STAFF REPORT

CITY OF COLUMBUS PLAN COMMISSION (April 8, 2026 Meeting)

Docket No. / Project Title: SUB-26-20 (Tipton Ridge Major Subdivision Preliminary Plat)
Staff: Andres M. Nieto
Applicant: Tim Thomas, PE
Property Size: +/- 107 acres
Current Zoning: RS4c (Residential: Single-family 4) w/ commitments
RMc (Residential: Multi-family) w/ commitments
Location: 7162 West State Road 46, in the City of Columbus.

C15

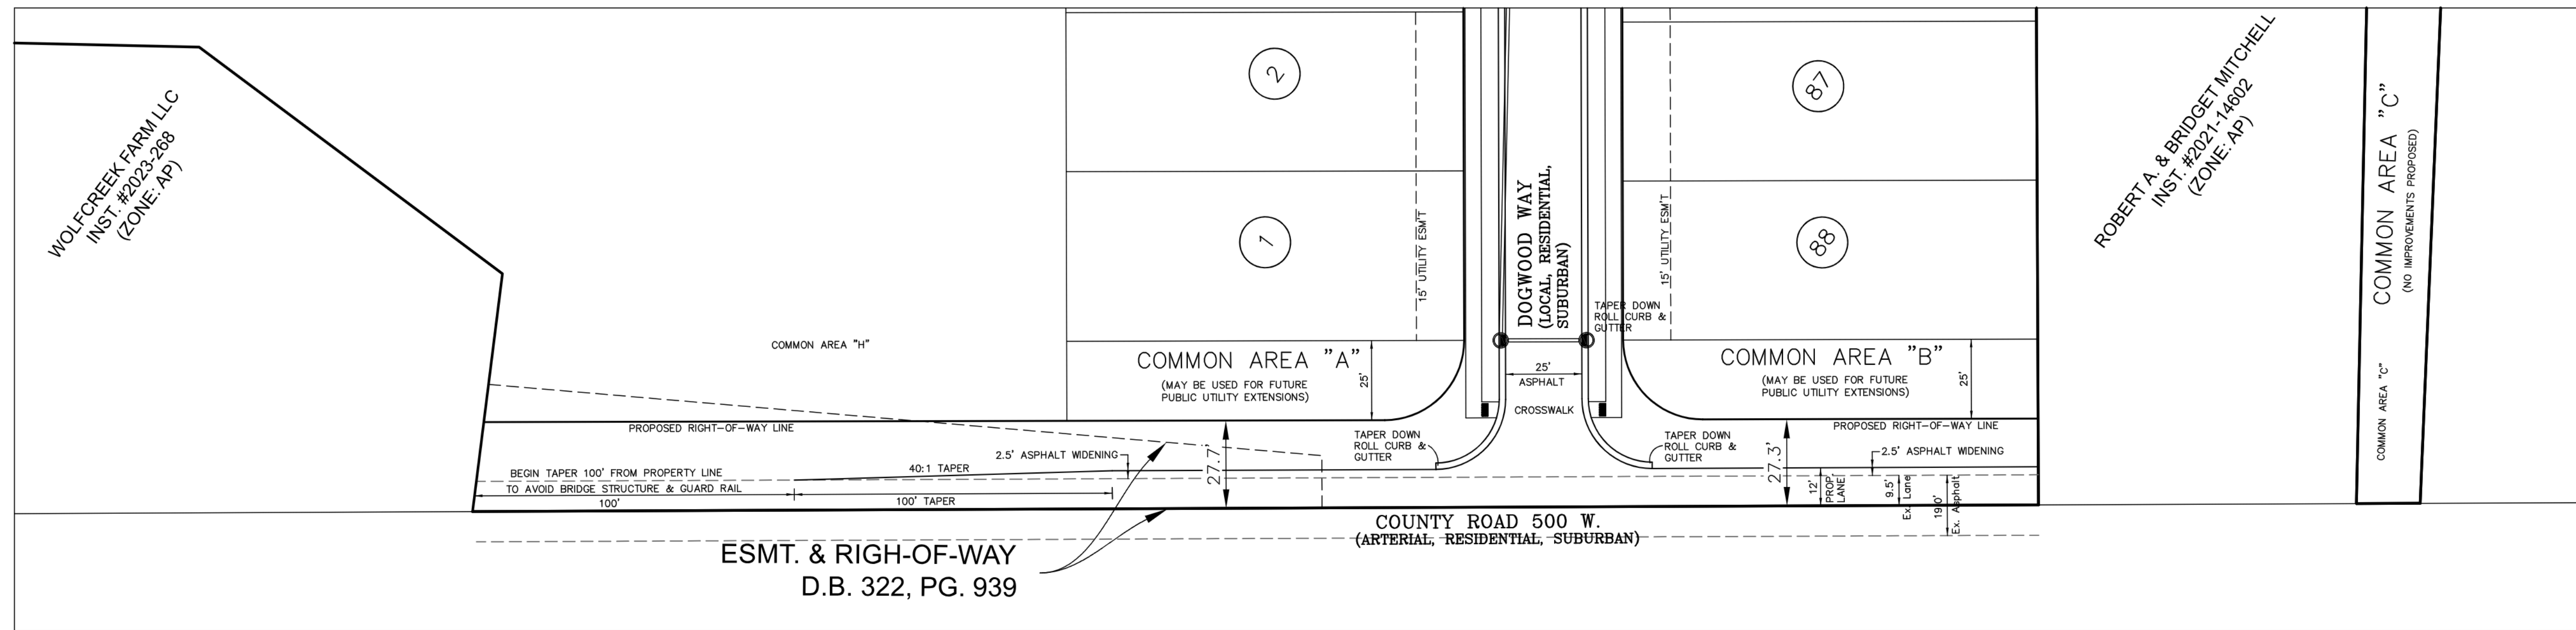
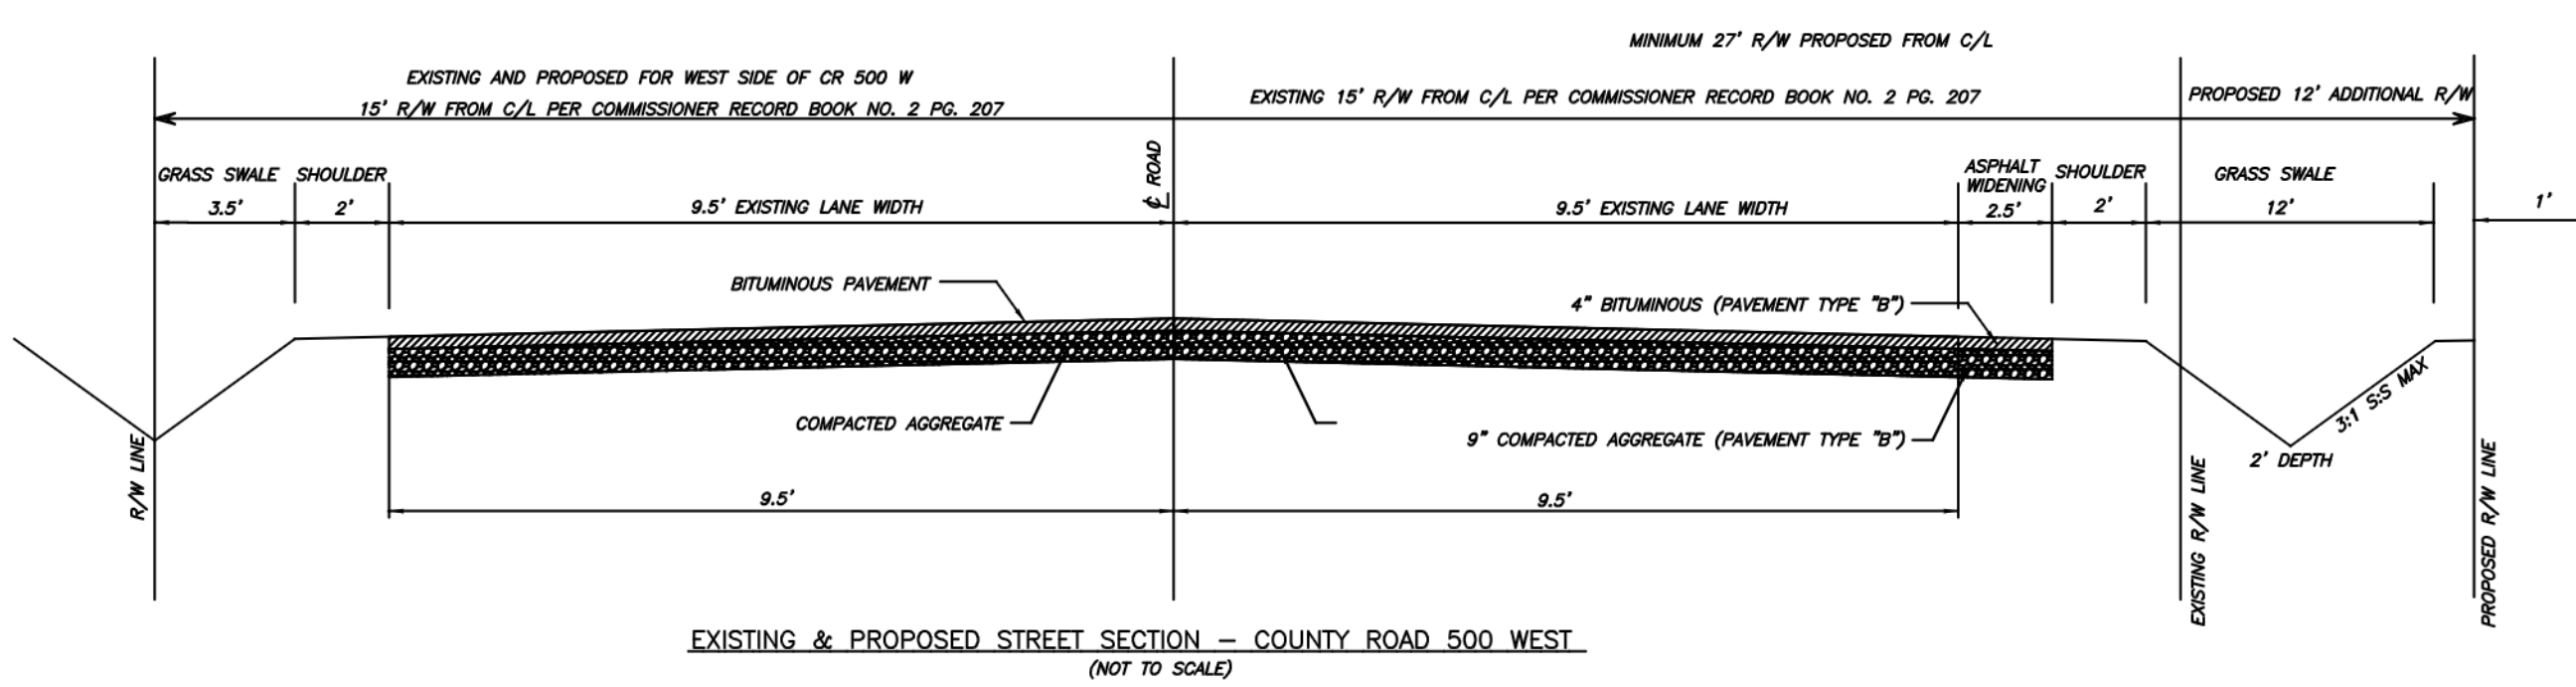
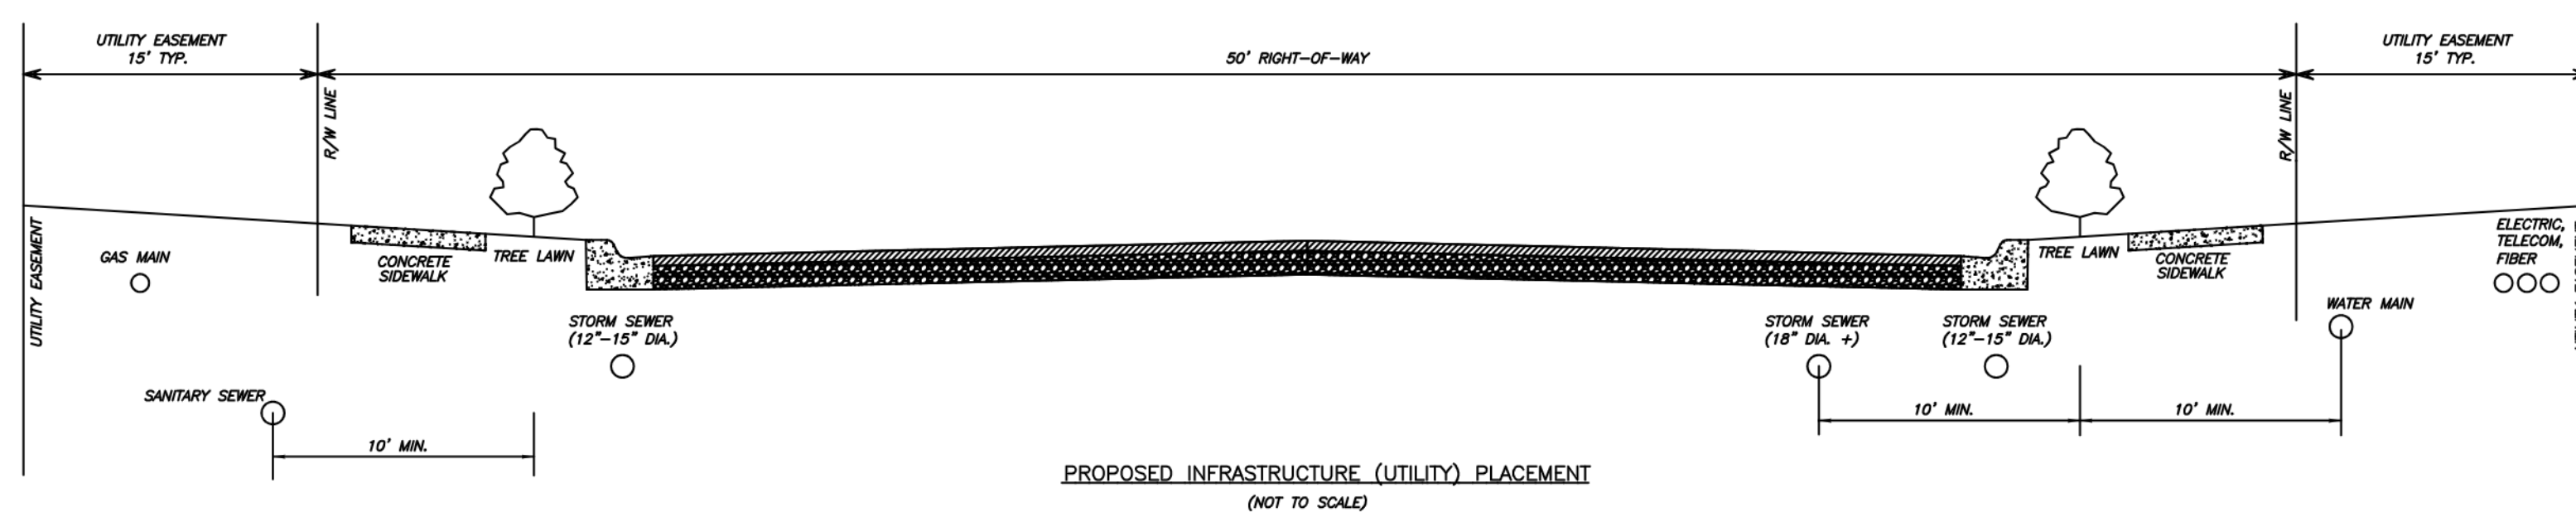
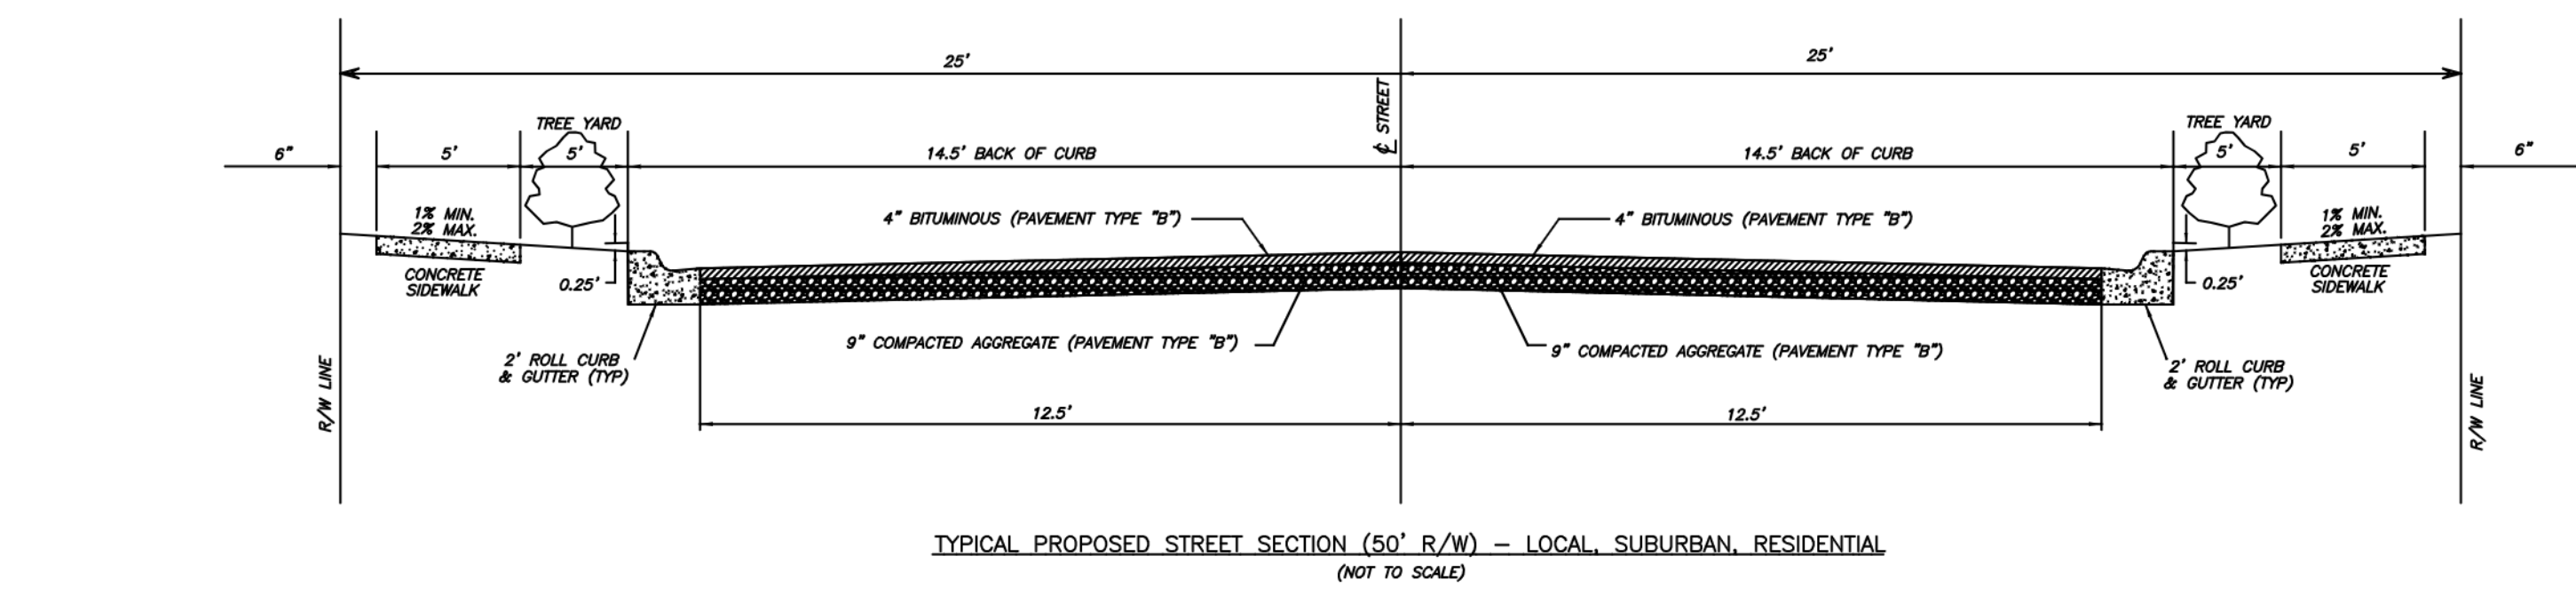
12. Sheet C15:
 - a. The 500 West cross-sections shall be revised to show a half right-of-way to match Sheets C3 and C8, and the "Proposed additional ROW" shall be revised to match Sheets C3 and C8, as well.

- b. The utility easement shown on the intersection detail of 500 West and Dogwood Way shall extend across the whole 500 West frontage of the site, rather than just being shown within the Common Area.

- d. In the intersection detail of Dogwood Way and Belmont Drive, curb ramps shall be shown on both sides of Belmont Drive located on the north side of Dogwood Way.
